UNITED STATES PATENT AND TRADEMARK OFFICE

APPLICATION NO.	FILING DATE	FIRST NAMED INVENTOR	ATTORNEY DOCKET NO.	CONFIRMATION NO.
10/797,950	03/10/2004	Toru Takuchi	42530-6800	4866

Office Action Summary	Application No. 10/797,950	Applicant(s) TAKEUCHI, TORU	
	Examiner Gerald W. McClain	Art Unit 3653

DETAILED ACTION

FIG. 10

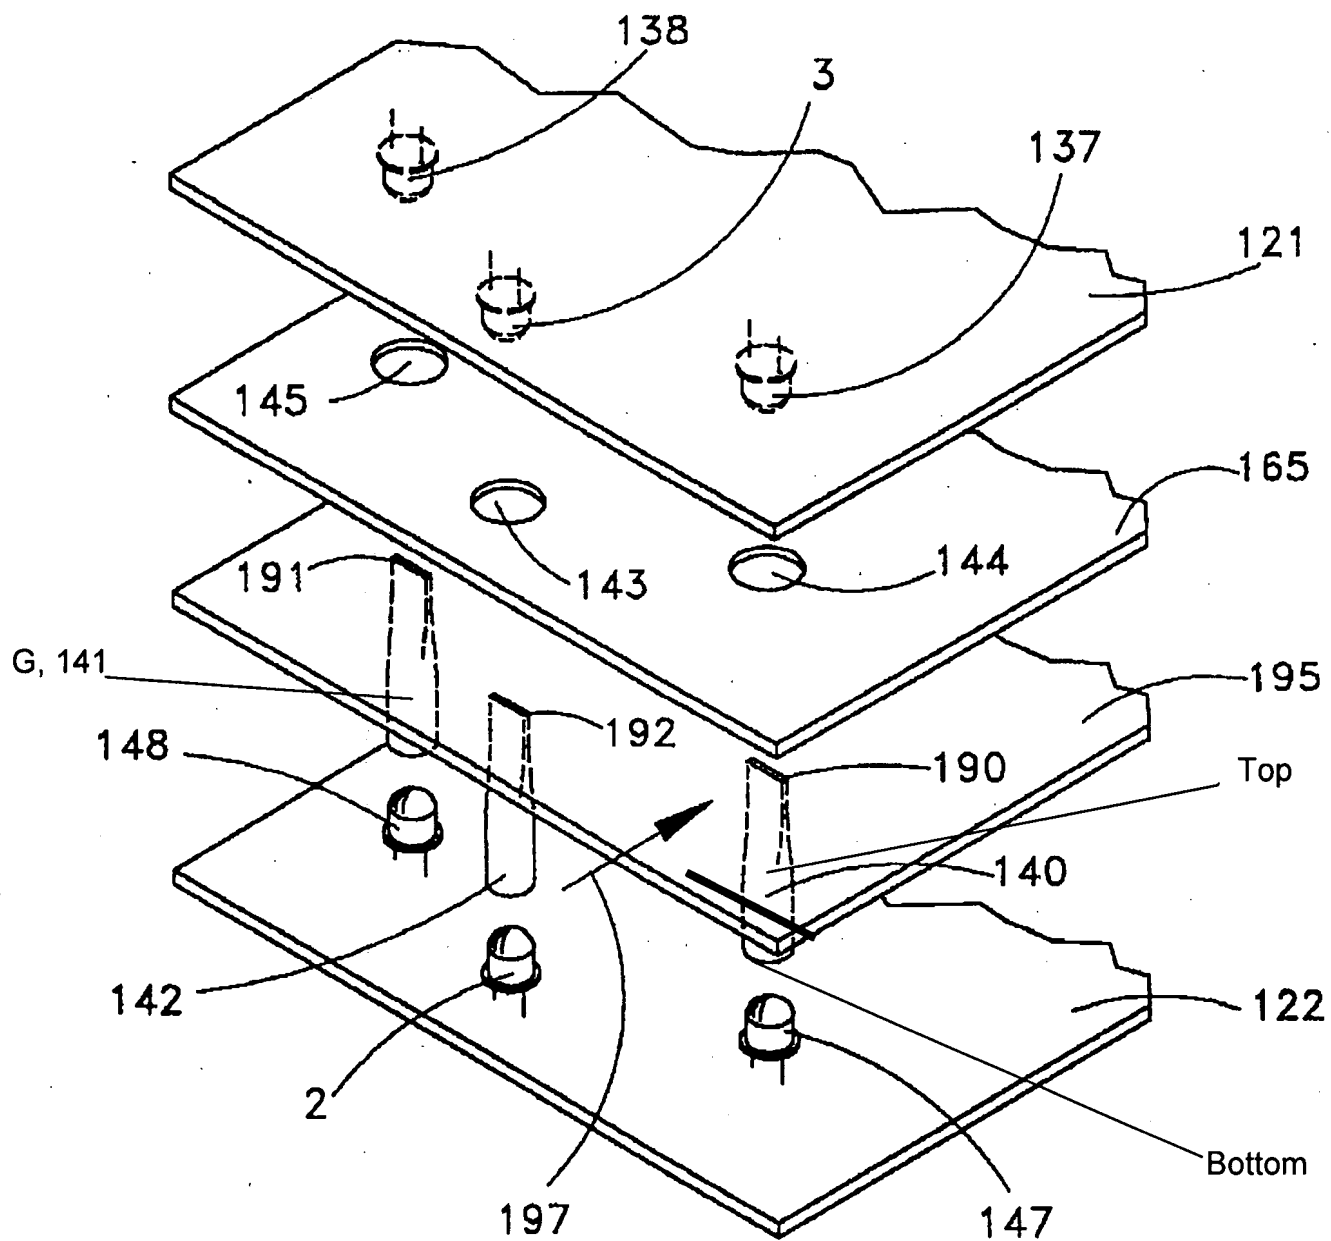
Claim 1: banknote storing unit (21, 22); banknote receiving unit (103); pushers (4, 5); moving unit (M2); optical guide units (See FIG. 10 below, 140, 142, G); light projecting surface (190-192); light receiving surface (See FIG. 10 below, 140, 142, G); surface (195); optical emitter-receiver pair units (See FIG. 10: 2, 147, 148; 3, 137, 138); light emitting element (See FIG. 10: 2, 147, 148); light receiving element (See FIG. 10: 3, 137, 138);

Claim 2: detecting projecting surface (See FIG. 10 below: top of 140, 142, and G); receiver section (See FIG. 10 below, curved sections of 3, 137, 138); optical emitter-receiver pair unit (See FIG. 10: 2, 147, 148; 3, 137, 138); detecting receiving surface (See FIG. 10 below: bottom of 140, 142, and G); emitter section (See FIG. 10 below, curved sections of 2, 147, 148);

Claim 3: detecting projecting surface (190-192); position detecting optical guide unit (See FIG. 10 below, 140, 142, G); light beam (column 8, lines 40-49); emitter section (See FIG. 10 below, curved sections of 2, 147, 148); position detecting emitter-receiver pair unit (See FIG. 10: 2, 147, 148; 3, 137, 138); reflector member (See FIG. 10 below: top of 140, 142, and G);

Claim 6: detecting projecting surface (See FIG. 10 below: top of 140, 142, and G); detecting receiving surface (See FIG. 10 below: bottom of 140, 142, and G);

Claims 9: **optical guide unit** (140); **first column** (See FIG. 10 below, top of 140); **second column** (See FIG. 10 below, bottom of 140); **first end of the first column** (See FIG. 10 below, bottom end of top of 140); **first reflecting surface** (See FIG. 10 below, bottom end cross section of top of 140); **first end of the second column** (See FIG. 10 below, top end of bottom of 140); **second reflecting surface** (See FIG. 10 below, top end cross section of bottom of 140); **side surface of the first column** (See FIG. 10 below, inside surface of top of 140); **detecting projecting surface** (190); **side surface of the second column** (See FIG. 10 below, inside surface of bottom of 140); **detecting receiving surface** (See FIG. 10 below, inside surface of bottom of 140); **light projecting surface** (See FIG. 10 below, bottom surface of the bottom of 140);

Claim 12: second end of the first column (See FIG. 10 below, bottom end of bottom of 140); projecting surface (See FIG. 10 below, bottom surface of the bottom of 140);

Claim 25: optical guide assembly (142); first reflecting surface (See FIG. 10 below, bottom end cross section of top of 140); second reflecting surface (See FIG. 10 below, top end cross section of bottom of 140); light projecting section (2); light receiving section (3);

FIG. G1

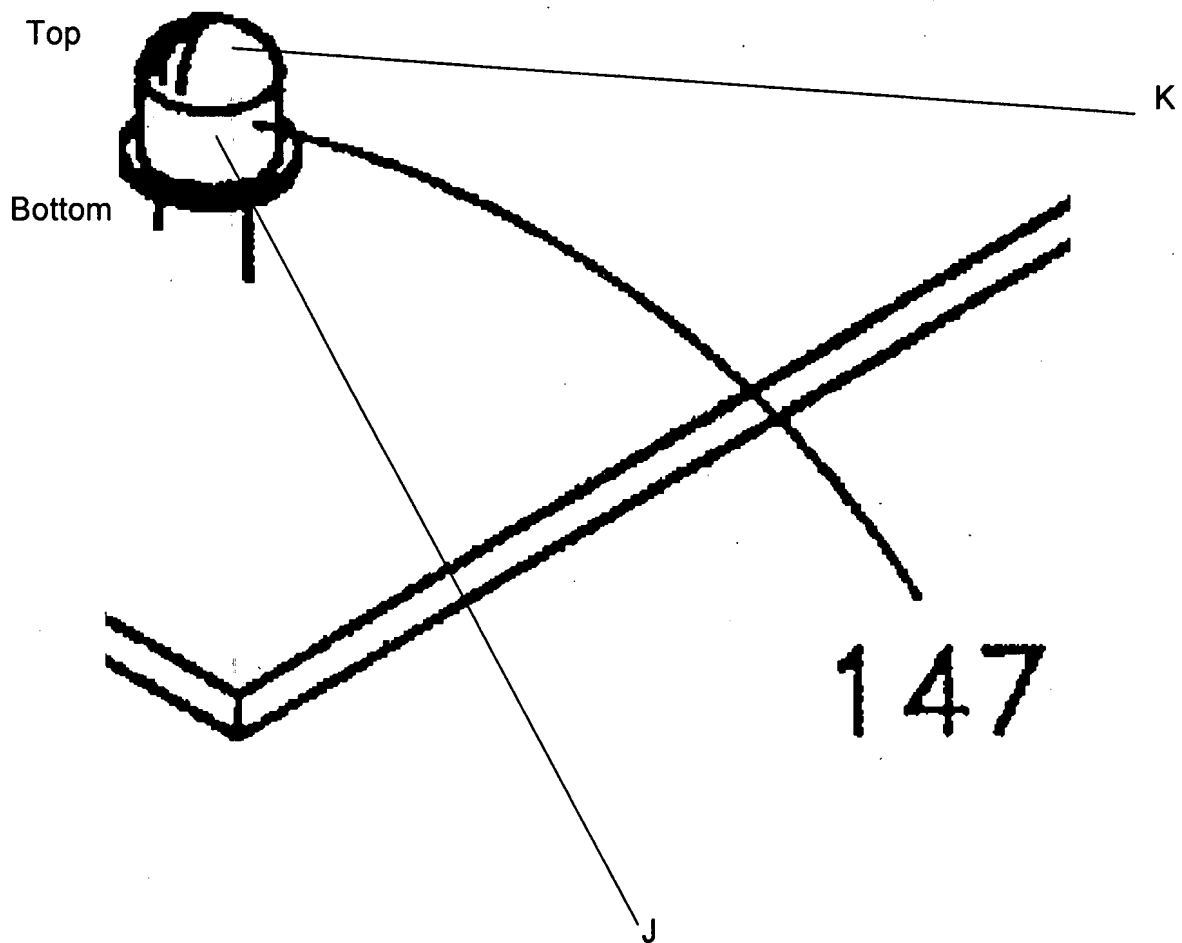
Claim 11: **emitter** (147); **light** (column 8, lines 40-49); **first cylinder** (See FIG. G1 below, J); **first end of the first cylinder** (See FIG. G1 below, top of J); **second end of the first cylinder** (See FIG. G1 below, bottom of J); **receiver** (137); **second cylinder** (See FIG. G2 below, H); **second end of the first cylinder** (See FIG. G2 below, bottom of H); **portion of light** (144 and column 8, lines 40-49); **second end of the second cylinder** (See FIG. G2 below, top of H);

Claim 24: projecting and receiving unit (2, 3); cylinders (See FIG. G1 below, J;
See FIG. G2 below, H); first cylinder (See FIG. G1 below, J); one end of the light

Claim 29: first and second cylinder (See FIG. G1 below, J; FIG. G2 below, H; respectively); one piece (See FIG. G1 below, J; FIG. G2 below, H);
